Access Compliance Report

Public Rights-of-Way

Intersection ID: 10034609	Main Street: PLANTATION_CENTER_DR	Cross Street: N/A	Location: NE
ADA ID: 69DC05B8697C	Ramp Type: Para	Initial Pass/Fail: Fail	Overall Compliance: No
Codes/Mitigation Info/Possible Solution		Field Measurements/Component Compliance	
Severity Score: 26.25

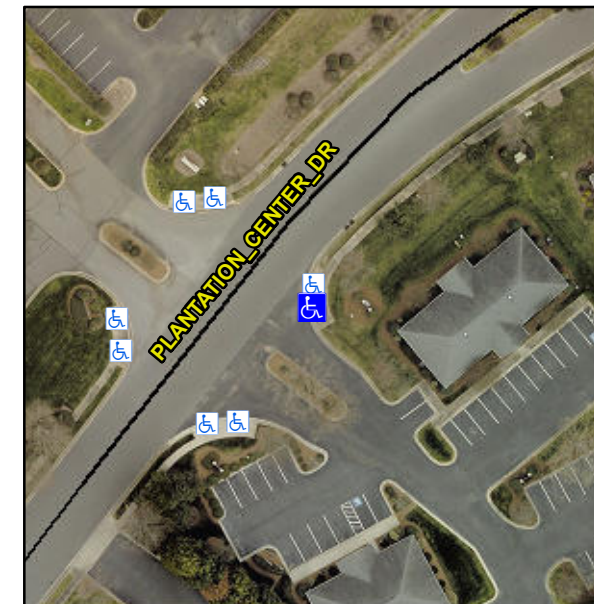
R304.3.2, R304.5.3

Compliance	Description	Data	Compliance	Description	Data
N/A	Ramp Length LT (in)	48.0	N/A	Ramp Length RT (in)	47.0
Yes	Ramp Width LT (in)	108.0	Yes	Ramp Width RT (in)	108.0
No	Ramp Slope LT (%)	12.4	No	Ramp Slope RT (%)	13.7
No	Ramp XSlope LT (%)	2.6	No	Ramp XSlope RT (%)	2.2
N/A	Landing Length (in)	N/A	N/A	DWS Provided?	N/A
N/A	Landing Width (in)	N/A	N/A	DWS Contrast?	N/A
N/A	Landing Slope (%)	N/A	N/A	DWS Length (in)	N/A
N/A	Landing X Slope (%)	N/A	N/A	DWS Full Width?	N/A
N/A	Landing Curb? (Y/N)	N/A	N/A	DWS Offset (in)	N/A
N/A	Shared Landing?	N/A			
N/A	Gutter Ponding?	N/A	N/A	Gutter Slope (%)	N/A
N/A	Gutter Lip Ht (in)	N/A	N/A	Gutter X Slope (%)	N/A
N/A	Painted X Walk1?	No	N/A	Painted X Walk2?	N/A
	X Walk 1 Direction	To SW		X Walk 2 Direction	N/A
N/A	X Walk 1 Width (in)	N/A	N/A	X Walk 2 Width (in)	N/A
	X Walk 1 Slope (%)	0.8		X Walk 2 Slope (%)	N/A
	X Walk 1 X Slope (%)	1.6		X Walk 2 X Slope (%)	N/A
N/A	Ramp inside XWalk1?	N/A	N/A	Ramp inside XWalk2?	N/A

Remove & Replace Entire Ramp.
